Submission to IPC from NAD-12 Hills of Gold Wind Farm SSD-9679

Summary of objections and issues:

Image on the front cover of the Hills of Gold Wind Farm State Significant Development Assessment Report (SSD 9679) December 2023

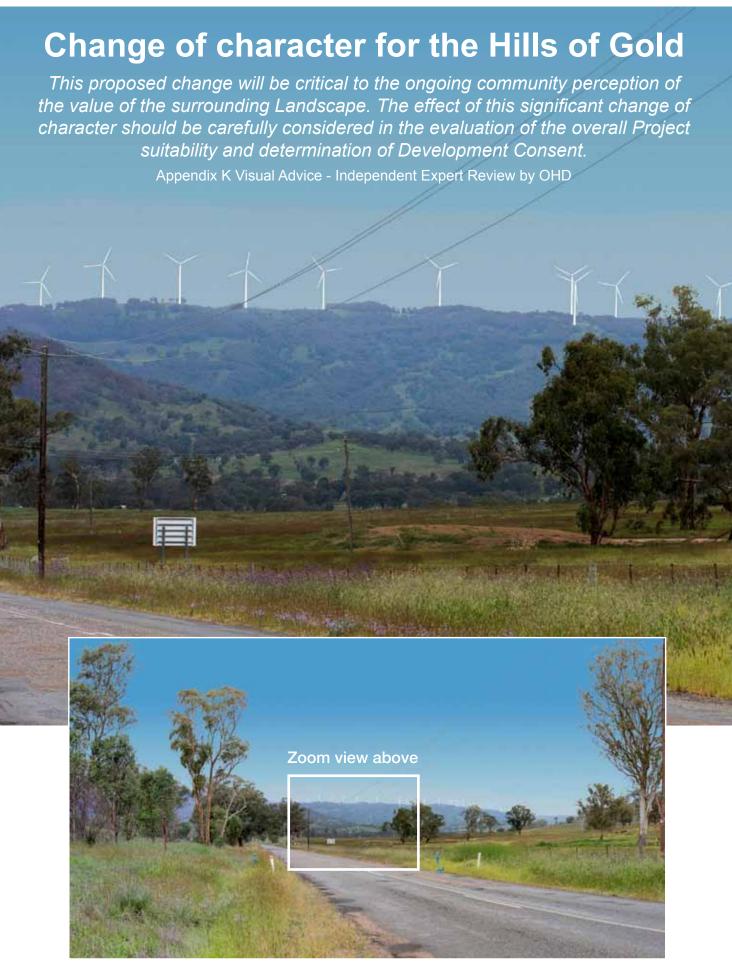
Does this image appear anywhere in any of the visual documents on the HoGWF or just on the cover of the Report? Showing turbines on low open country, this image misrepresents the Hills of Gold Wind Farm.
